PD Modification Application: MM 25-0353**Zoning Hearing Master Date:**

**Hillsborough
County Florida**

Development Services Department

The applicant is requesting a modification to the Planned Development to remove Auto Repair/Motor Vehicle – Neighborhood Serving as a prohibited use. A “Take 5” auto service repair station is proposed to be developed on the site.

8.2 Proposed Site Plan (Full)

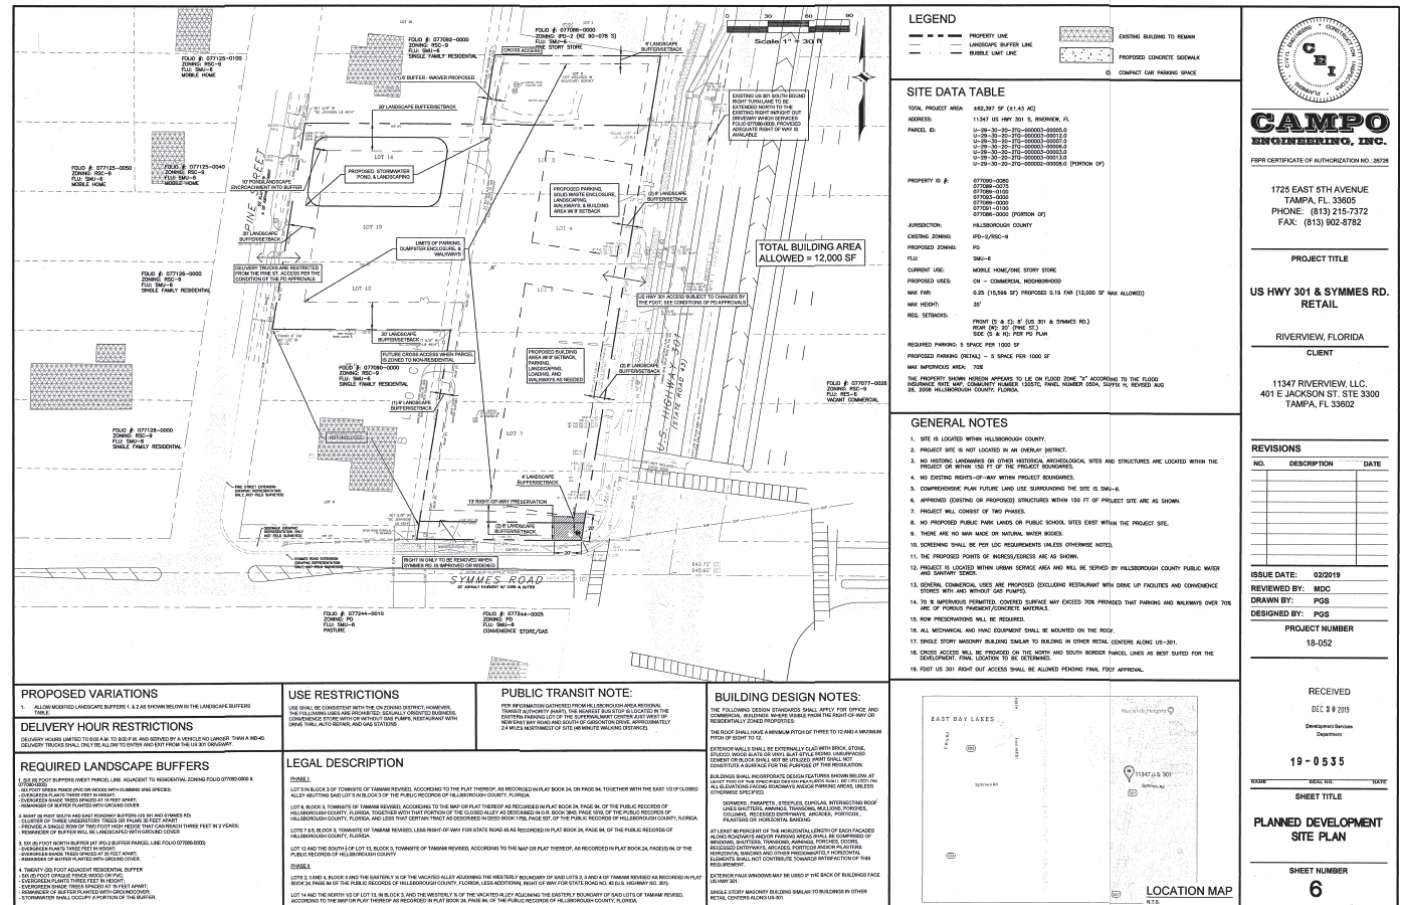
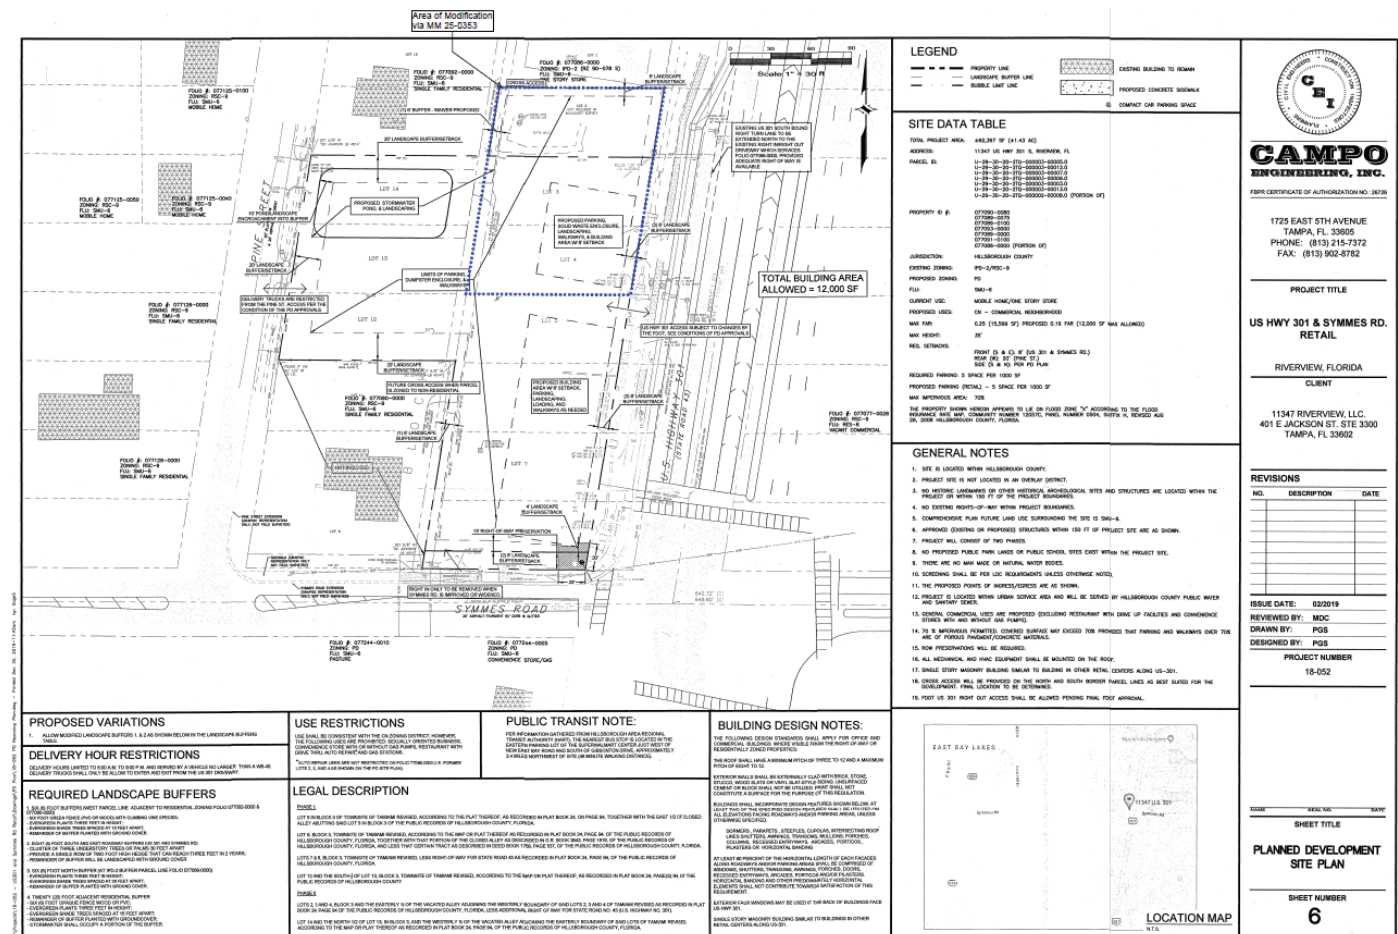
Staff notes that the above condition did not match the use restrictions contained on the PD site plan, which stated:

USE SHALL BE CONSISTENT WITH THE CN ZONING DISTRICT; HOWEVER, THE FOLLOWING USES ARE PROHIBITED: SEXUALLY ORIENTED BUSINESS, CONVENIENCE STORE WITH OR WITHOUT GAS PUMPS, RESTAURANT WITH DRIVE THRU, AUTO REPAIR, AND GAS STATIONS .

The applicant is seeking to modify a portion of the PD to allow auto-repair uses within the modification area (i.e. within folio 77089.0000, labeled as former lots 2, 3 and 4 as shown on the PD site plan).

1. The project shall be limited to the uses consistent with the Commercial Neighborhood (CN) Zoning District with the following restrictions: sexually oriented business, convenience store with or without gas pumps, restaurant with drive thru, and gas stations. Auto Repair/Motor Vehicle – Neighborhood Serving shall only be permitted on Folio# 77089.0000.

PINE STREET TYPICAL SECTION

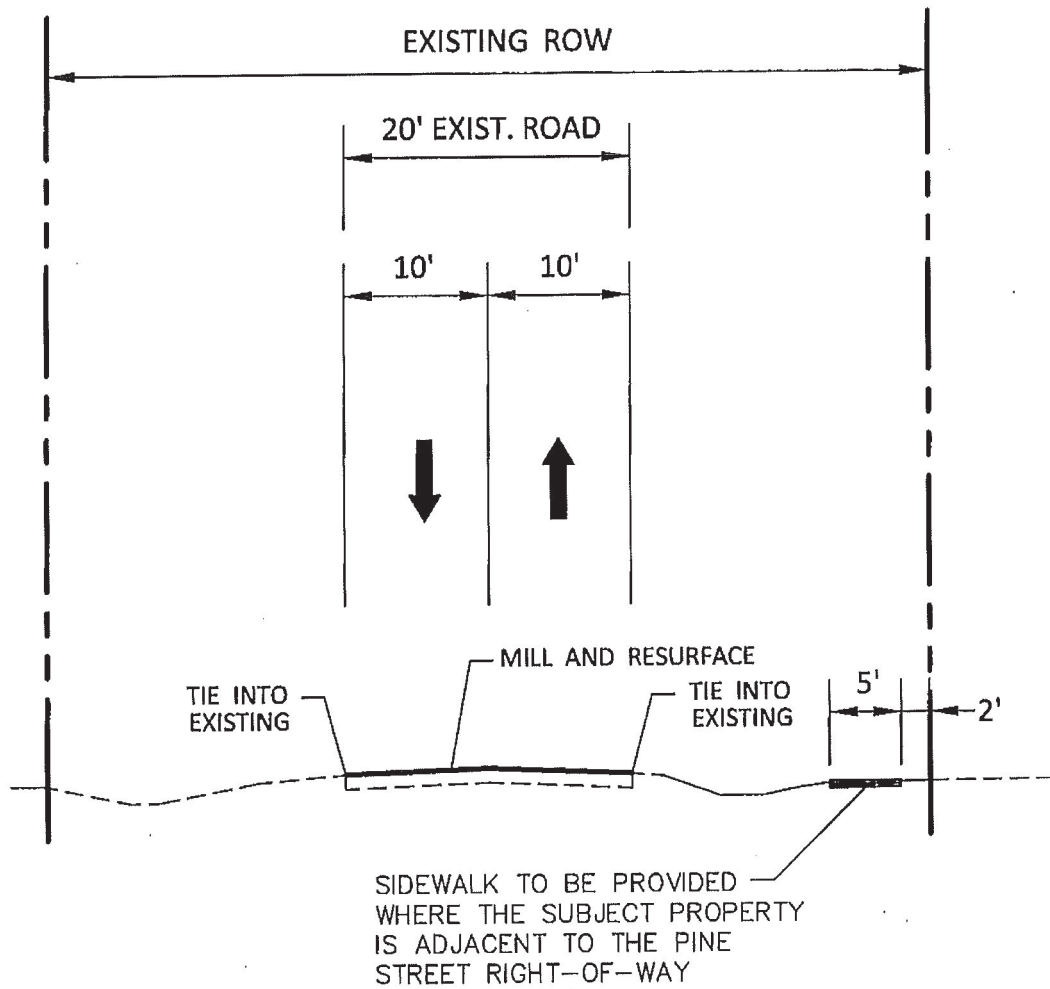
The purpose of this letter is to request a Design Exception to Section 6.04.03L of the Hillsborough County Land Development for Pine Street from the project access to Symmes Road. The project is located west of US 301 and north of Symmes Road. The developer proposes to rezone the property to Planned Development to allow the following uses:

This request is for a Design Exception to TS-7 of the Hillsborough County Transportation Technical Manual for Pine Street from the project access to Symmes Road. Pine Street is currently a two-lane roadway. The existing pavement is 20'. Table 1 provides the summary of the roadway assessment for Pine Street. The Design Exception is based on the following:

1. Lane Width – TS-7 has 12' lanes. As shown in Table 1, the existing lanes are 10'. The Typical Section proposes to maintain the existing lane width and overlay the roadway with 1" of asphalt.
2. Shoulder – TS-7 has 8' shoulders with 5' paved. This section proposes to maintain the existing shoulders.
3. Sidewalk – TS-7 has sidewalk on both sides of the road. The proposed section does provide sidewalk on the east side of the roadway where the project is adjacent to Pine Street.

1. There is limited right of way along Pine Street and the project has limited frontage along the roadway.
2. Pine Street is a low volume roadway; 17 AM peak hour trip ends and 13 PM peak hour trip ends.

☒ Approved

The County Engineer has reviewed zoning modification application # 25-0353 and determined the changes to be de minimis. As such, the previous approval shall stand.
